Product Change Notification

Change Notification #: 117643 - 00
Change Title: Intel® NUC Rugged Chassis Element
CMCR1ABA,
Intel® NUC Rugged Chassis Element
CMCR1ABB,
117643-00, Product Design, Label
Documentation,
Update rating label, safety/caution
document, carton label and Embedded
Controller Firmware revision
Date of Publication: June 16, 2020

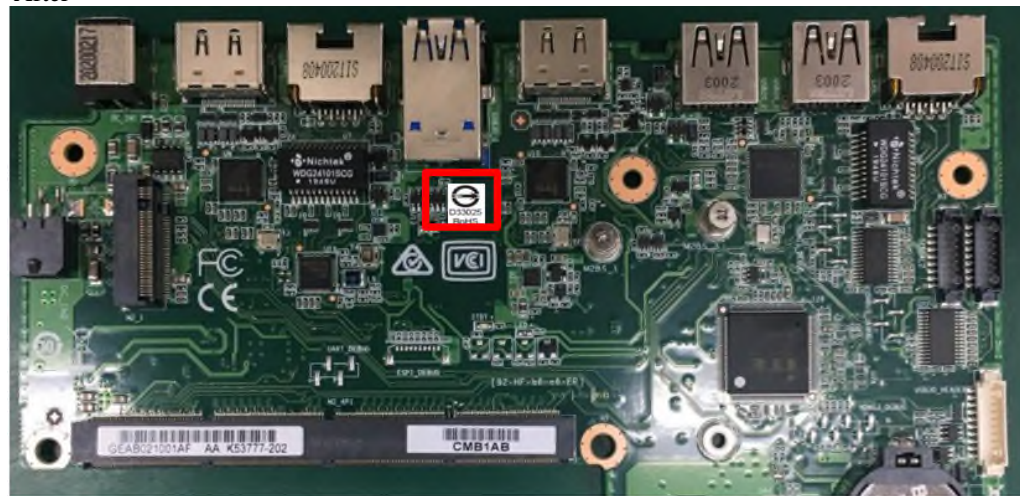
1. Update rating label by adding BSMI logo on board

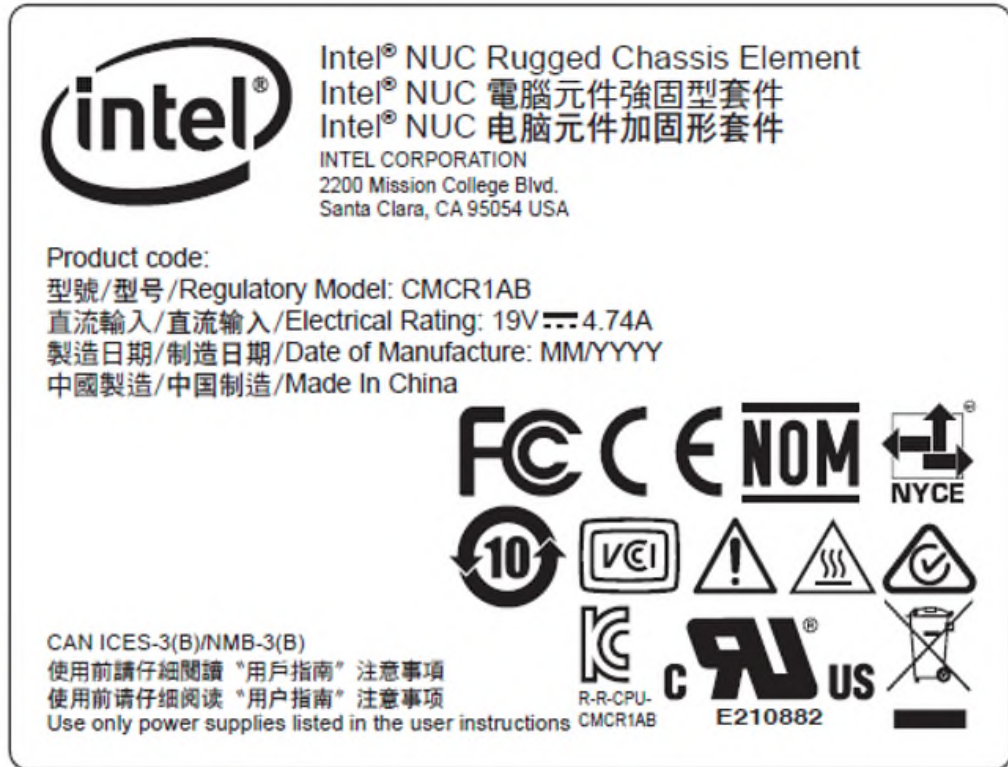
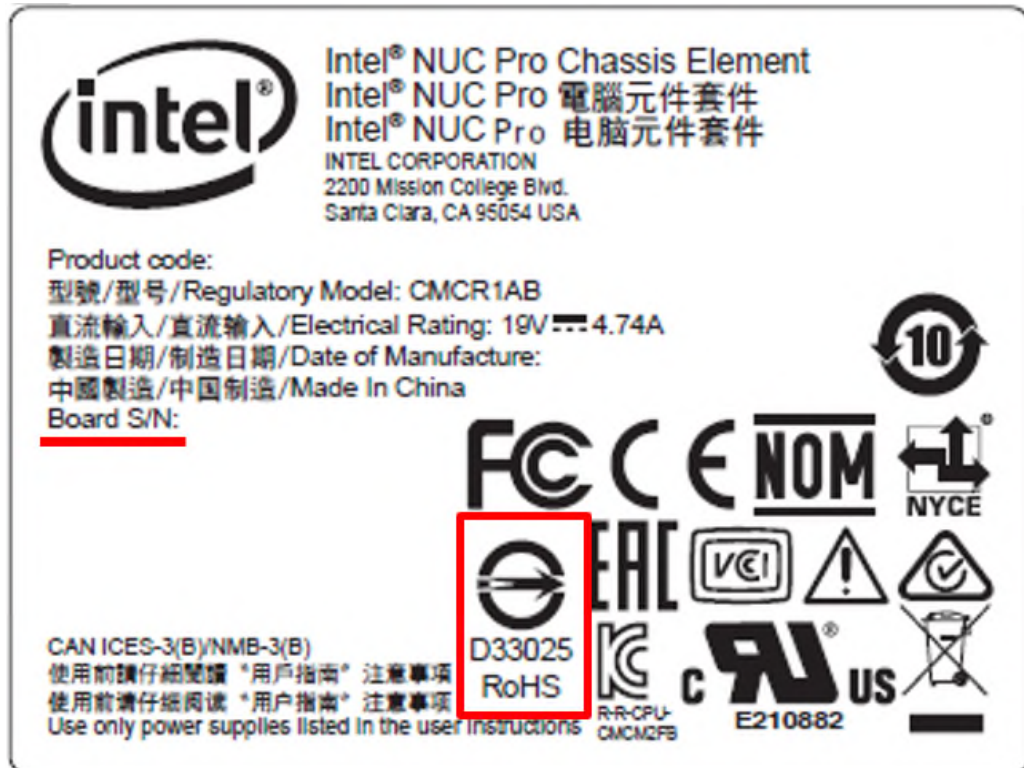
2. Update Rating label by adding BSMI logo on chassis.

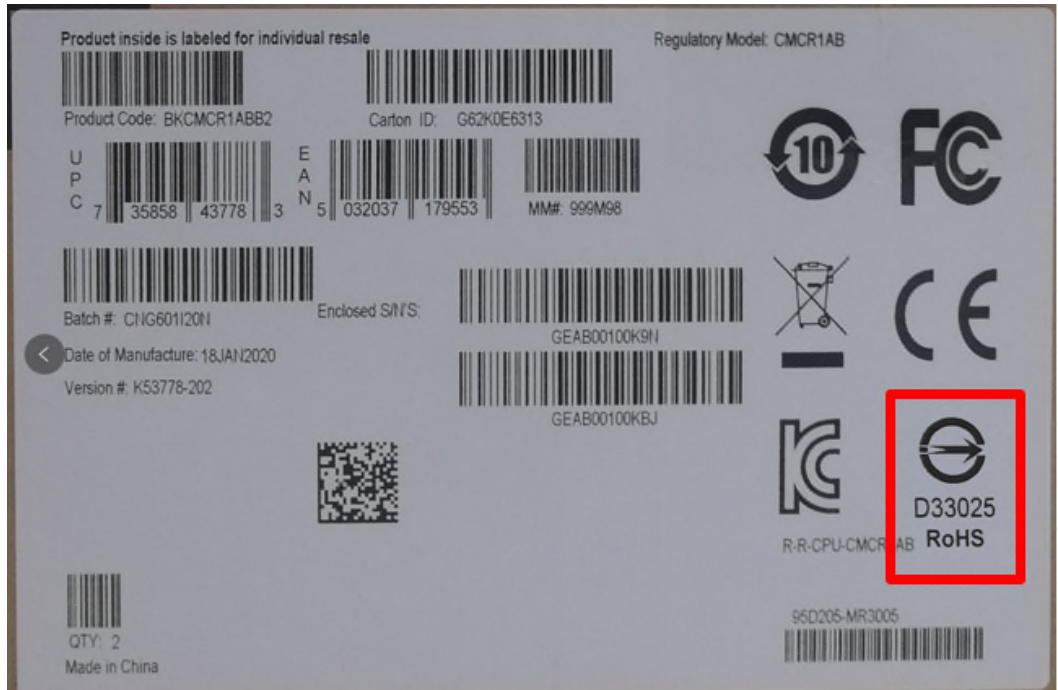
3. Update kit carton label by adding BSMI logo
